<b>Model</b>	F5 LCT (Ricoh RT32, NRG T251)	<b>Volt/Hz</b>	<b>Date of Modification</b>	<b>Serial Number</b>
<b>Modified Article</b>	Cushion - Motor	A459 - 17		
<b>Reason for Modification</b>	To standardize with other models			
		A459 - 22

<b>Model</b>		F5 LCT (Ricoh RT32, NRG T251)					<b>Code</b>	<b>Model Name</b>	<b>Serial Number</b>	
<b>Modified Article</b>		Upper Cover, etc.					A459 - 17	RT32	A355100001	
<b>Reason for Modification</b>		To comply with the CE mark standards (For A459-22, -27) To standardize the parts (For A459-17)					A459 - 27	RT32	A355080001	
							A459 - 22	T251	621508XXXX	
Draw No.	Old Parts No.	New Parts No.	Description	Rank	Q'ty Used Old→New	Inter-change-ability	Parts needed for replacement by new part		Parts Catalog	
							Part No.	Description	No.	Page
<b>Information for the Ricoh European version model (A459 - 27) starts from this bulletin. MB No. 1 is for the other versions (A459 - 17, A459 - 22) only.</b>										
1	A4591206	A4591208	Upper Cover		1 → 1	X/O	(O/O for the U. S. A. version.)		3	5
1	A4591320	A4591323	Hinge Bracket Cover		1 → 1	X/O	(O/O for the U. S. A. version.)		16	5
1	A4591310	A4591313	Hinge Bracket		1 → 1	X/O	(O/O for the U. S. A. ver

**Drawing No. 1**

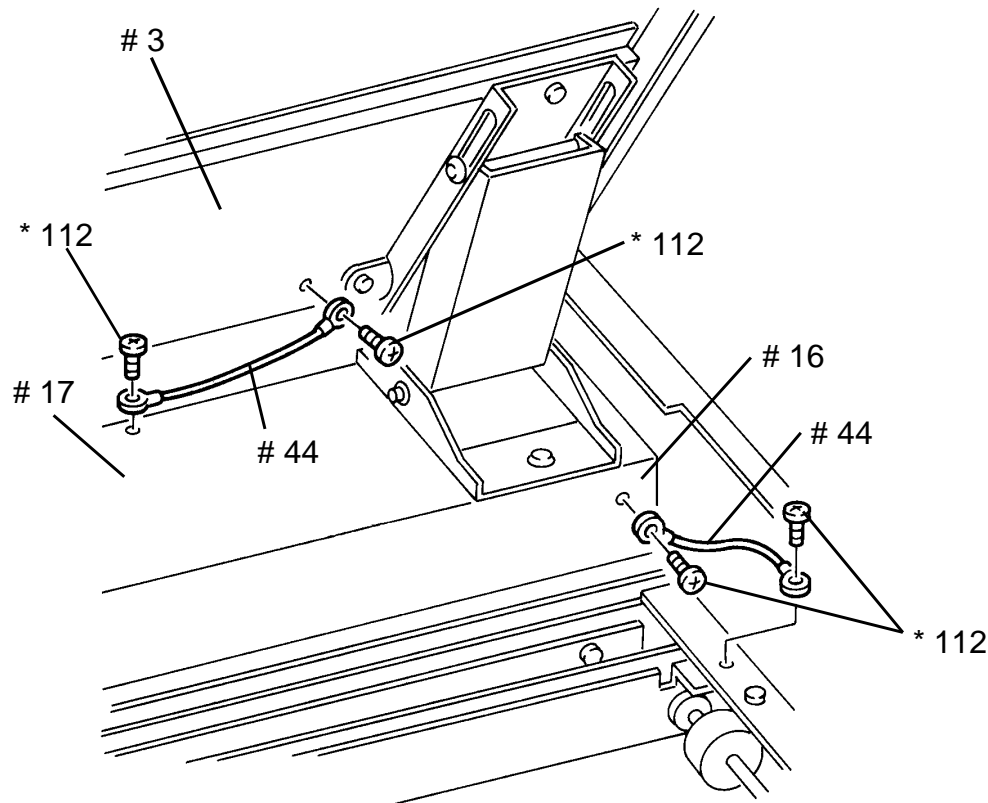
To comply with the CE mark standards, the parts described on the previous pages have been changed.  
 For the U. S. A. version units (A459-17), some parts have been changed as described for the parts standardization.

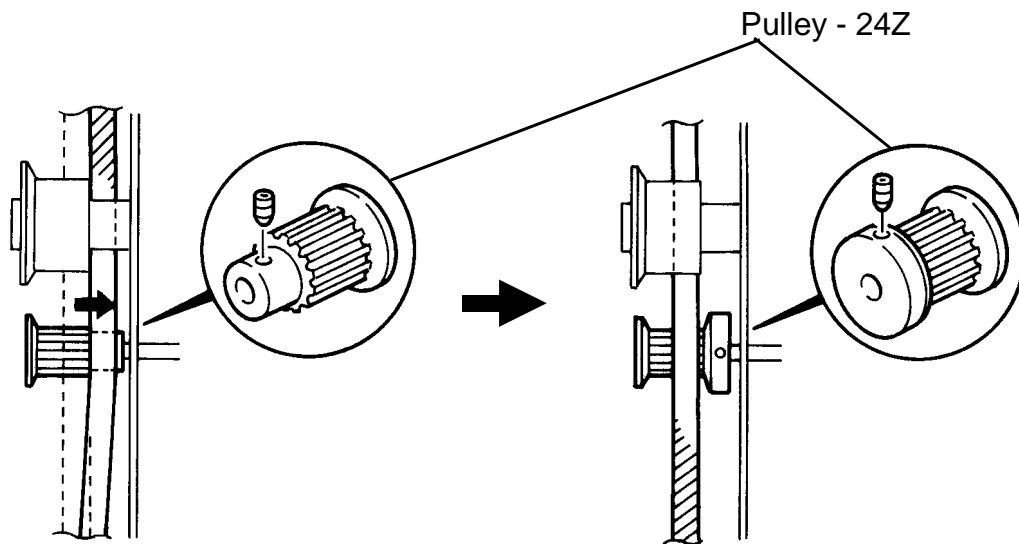
To prevent the timing belt from slipping off the pulley, the pulley has been changed so that there are flanges at both ends.

Old P/N	New P/N	Description	Q'ty Used	Inter-changeability	Parts Catalog	
					Index No.	Page
A4591551	A4591553	Pulley - 24Z	2 → 2	X/O	41	5

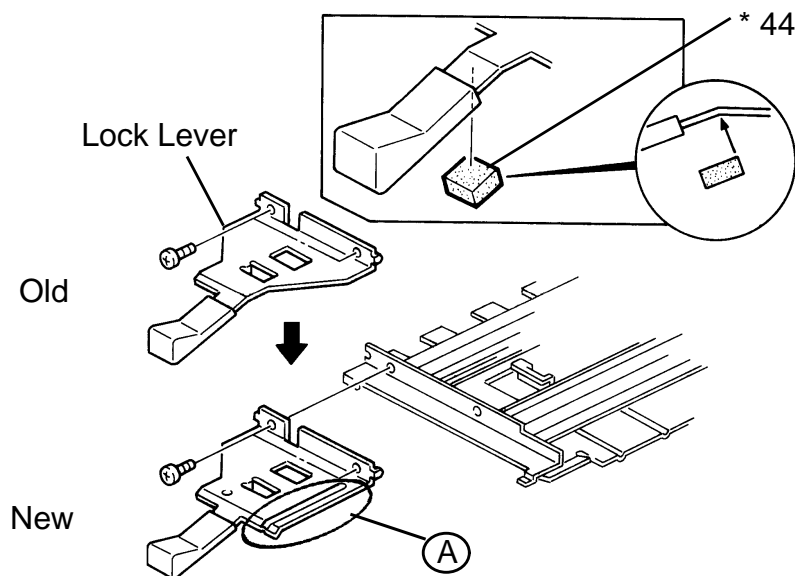
When the lock lever is bent, the transport driven roller shaft is scraped by the center guide plate. To prevent this, the lock lever has been strengthened (A) and a cushion has been added. The part number of the lock lever has not changed.

New P/N	Description	Q'ty Used	Parts Catalog	
			Index No.	Page
AA162075	Cushion - 7 x 9 x 20	0 → 1	* 44	15

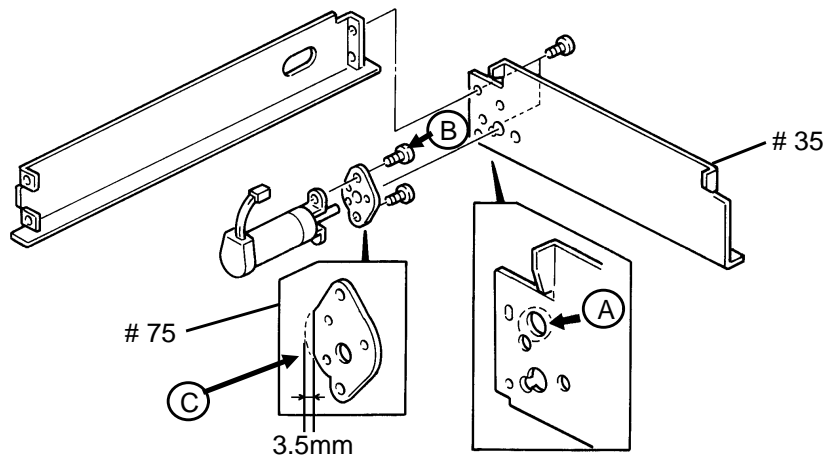
To facilitate assembling, the following parts have been modified.

1. Rear Side Plate - Transport  
A hole (A) (φ10) has been added as shown to prevent it from coming in contact with screw (B).
2. Transfer Drive Motor Bracket  
A cover (C) of the motor bracket has been cut off to prevent it from touching against the transport left stay.

Old P/N	New P/N	Description	Q'ty Used	Inter-change-ability	Parts Catalog	
					Index No.	Page
A4591515	A4591527	Rear Side Plate - Transport	1 → 1	X/O	33	5
A4591559	A4591568	Transfer Drive Motor Bracket	1 → 1	X/O	75	5

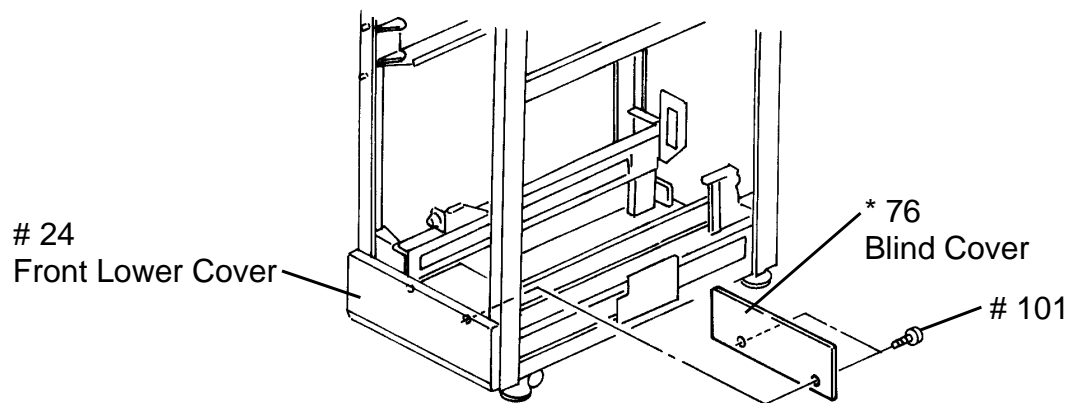
To meet UL standardization, the blind cover has been added as shown.  
 This cover prevents a customer from coming in contact with the electrical parts.

Old P/N	New P/N	Description	Q'ty Used	Inter-changeability	Parts Catalog	
					Index No.	Page
A4591266	A4591268	Front Lower Cover	1 → 1	X/O	24	5
	A4591270	Blind Cover	0 → 1		* 76	5
	03140060W	Philips Pan Head Screw - M4 x 6	n → n+2		101	5
